## Dimensioning #1

# Profile of a cone

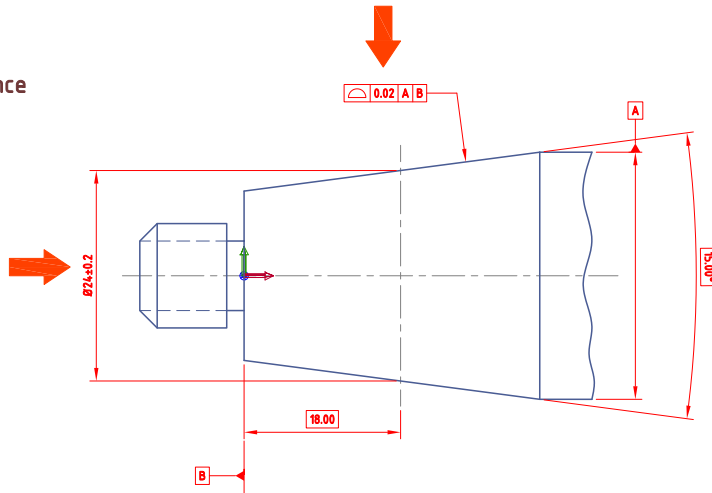
The Plus-Minus Tolerance doesn't match the Profile Tolerance.  
*Dimensioning seems to be wrong.*

## Dimensioning #2

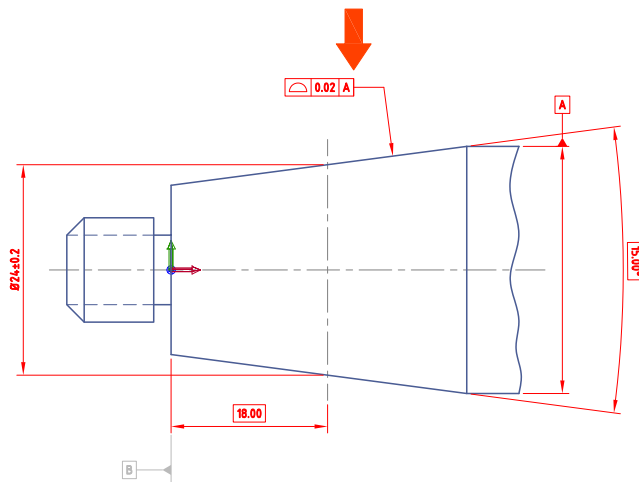
*Datum B omitted.*  
The Plus-Minus Tolerance determines the horizontal location of the cone.

## Dimensioning #3

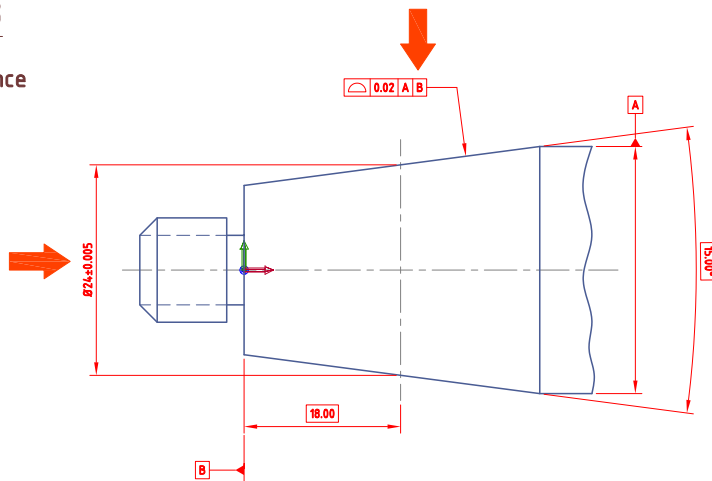
The Plus-Minus Tolerance as a local refinement.  
Kind of "FRTZF".  
 $\pm 0.005 < 0.020$

Pic. #2

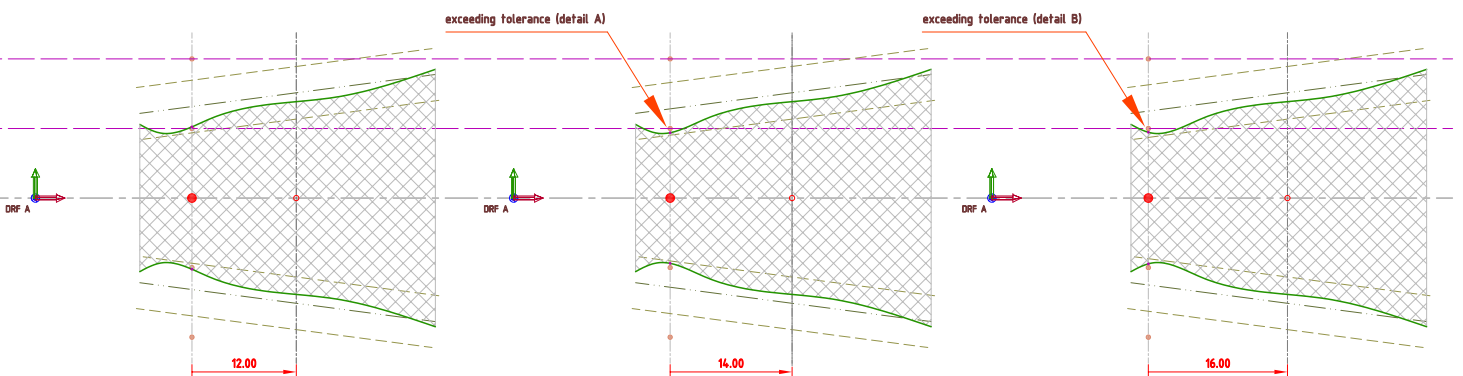
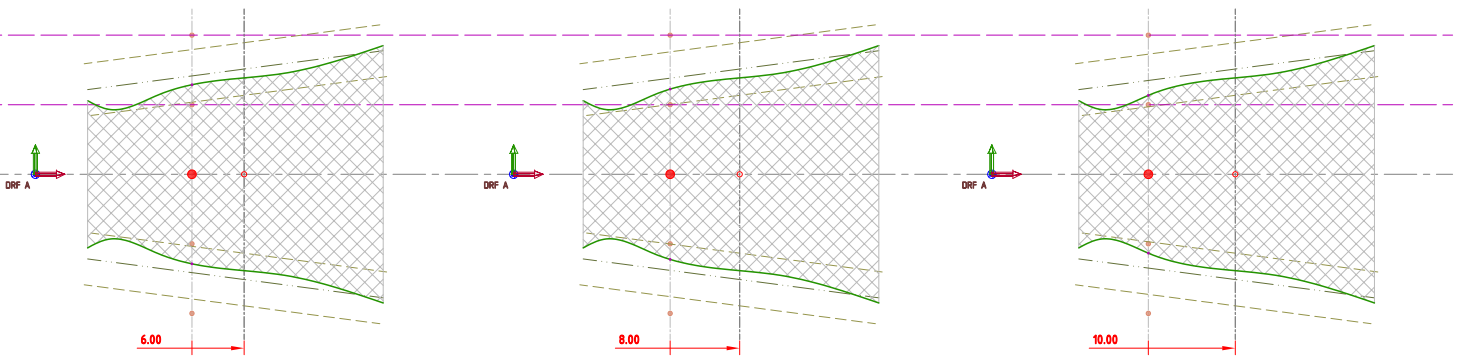
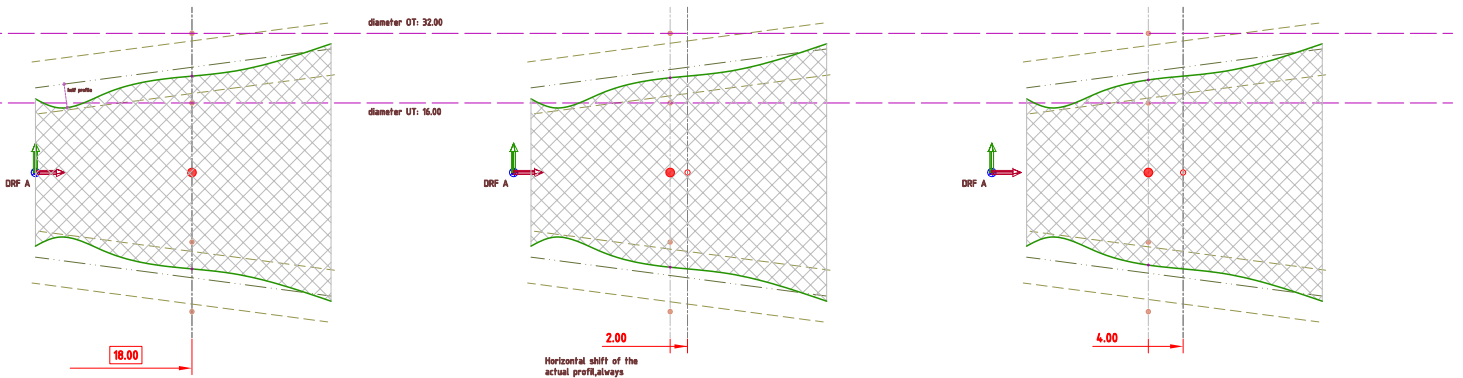
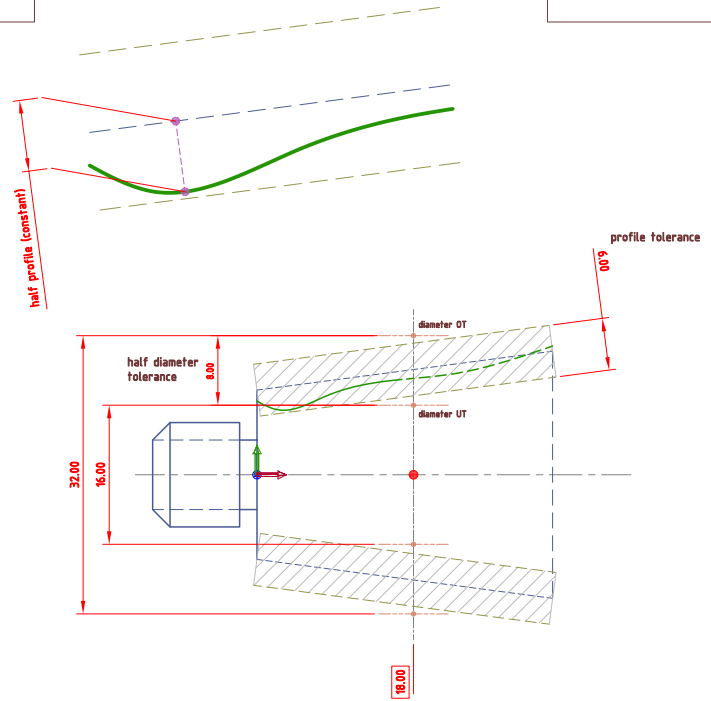
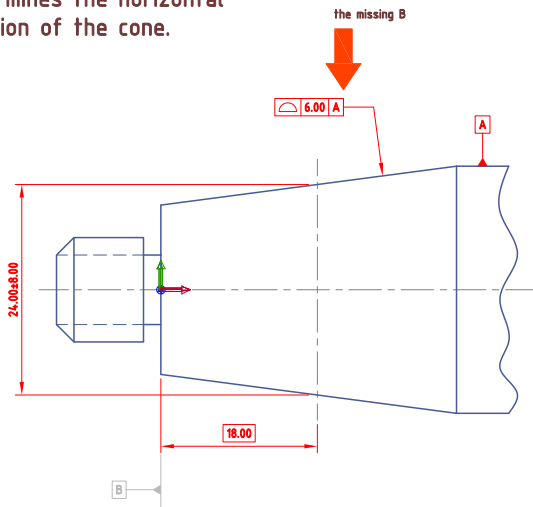
The Plus-Minus Tolerance determines the horizontal location of the cone.

Pic. #4

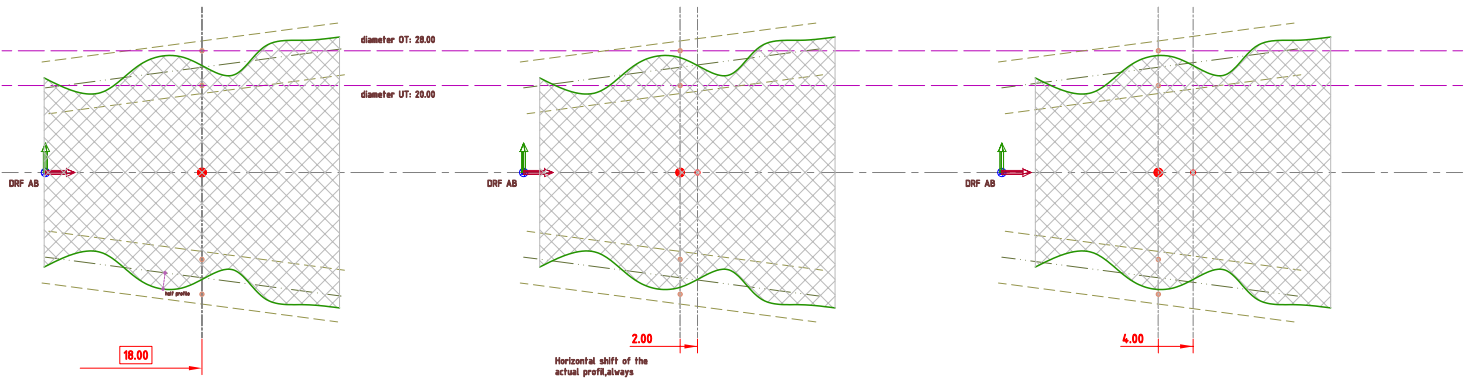
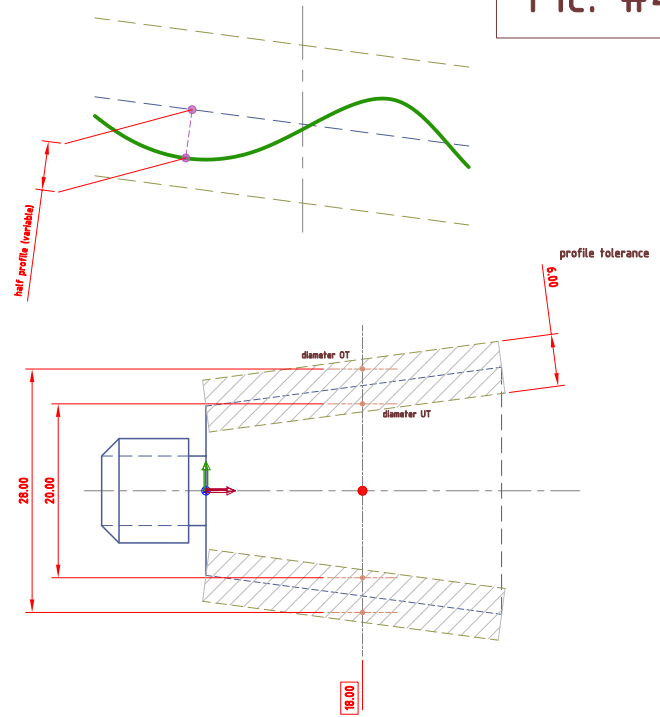
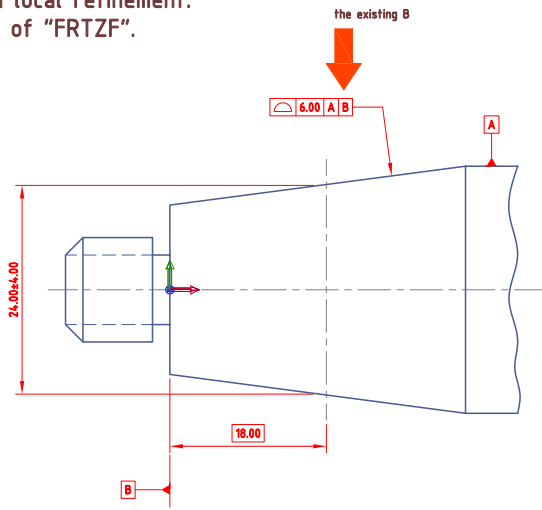
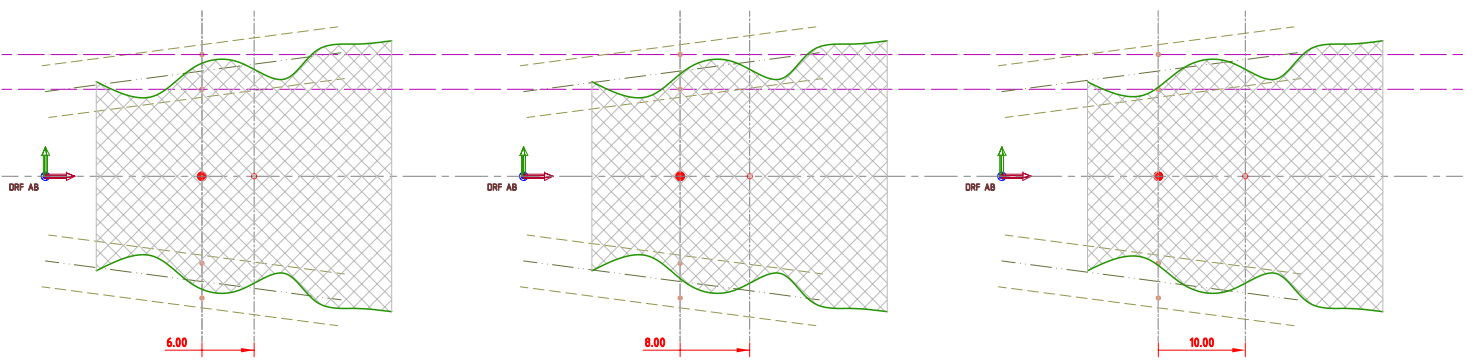
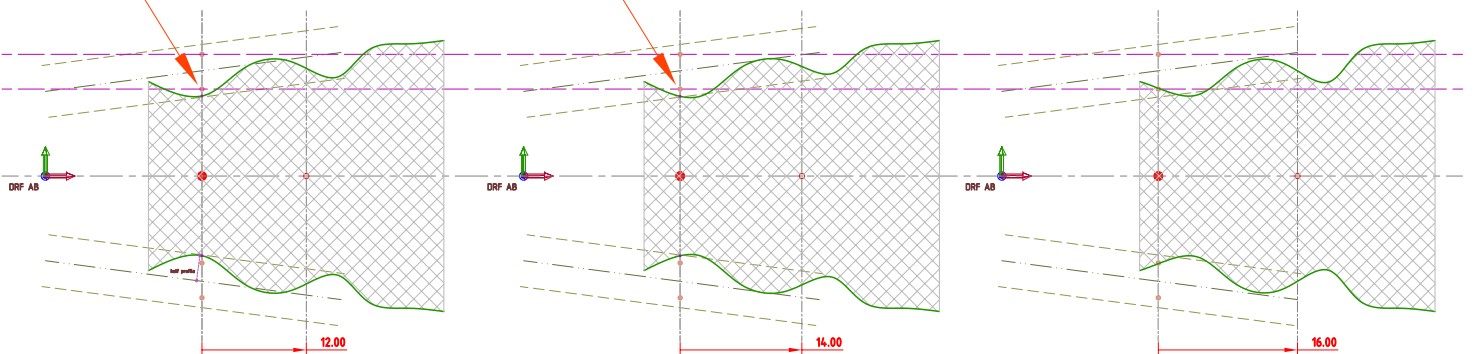
The Plus-Minus Tolerance as a local refinement.  
Kind of "FRTZF".

Horizontal shift of the actual profile, always constrained to datum A and B. The tolerance zone of profile keeps it's position.

exceeding tolerance (detail A)

exceeding tolerance (detail B)

Pic. #6

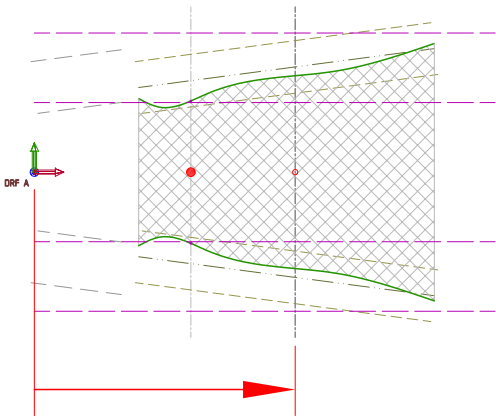
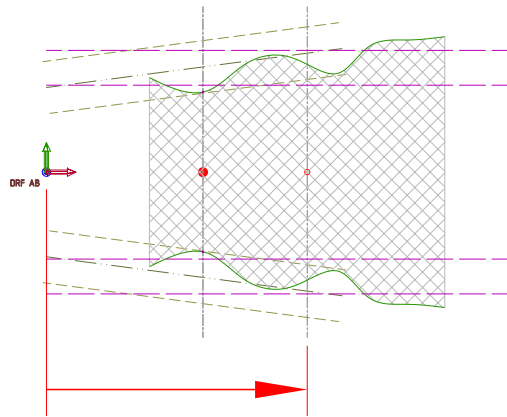
Horizontal shift of actual profile and Profile Tolerance within the limits of  $\pm 8.00$

Horizontal shift of actual profile within the limits of  $\pm 4.00$

The Plus-Minus Tolerance doesn't match the Profile Tolerance.  
*Dimensioning seems to be wrong.*
